F/CMVSS Noncompliance Recall

18159 Fuel Leak During F/CMVSS Testing

Reference Number: N182159480

Release Date: May 2018
Revision: 00

5065757

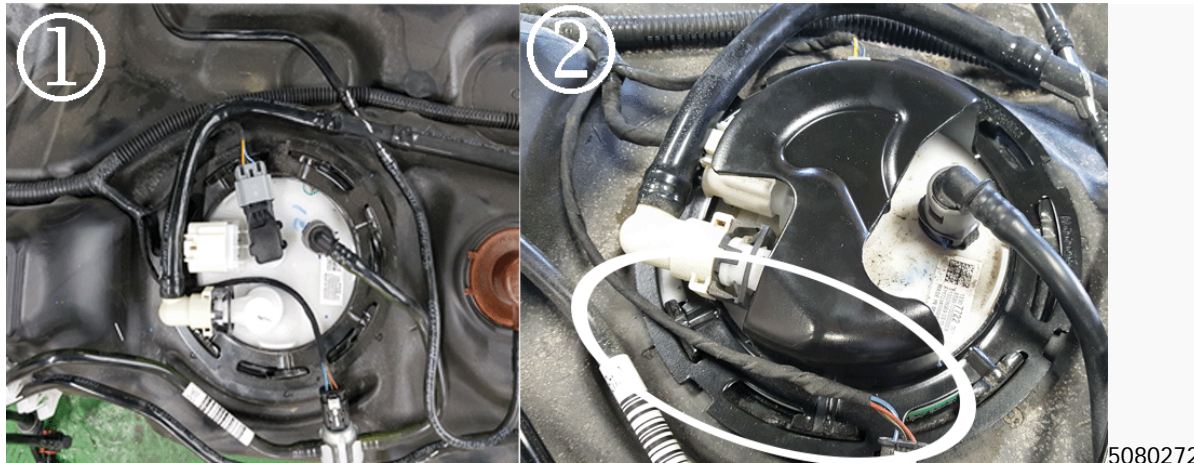
4. Replace the locking cam (1) with the new style locking cam (2) with a helmet. Be sure to route the wire harness (circled) **exactly as shown** in 2, as the routing differs from 1.
5. Reinstall the fuel tank and lower the vehicle.

Correction	Dealers will install a lock-ring on the fuel tank that shields the VPS.
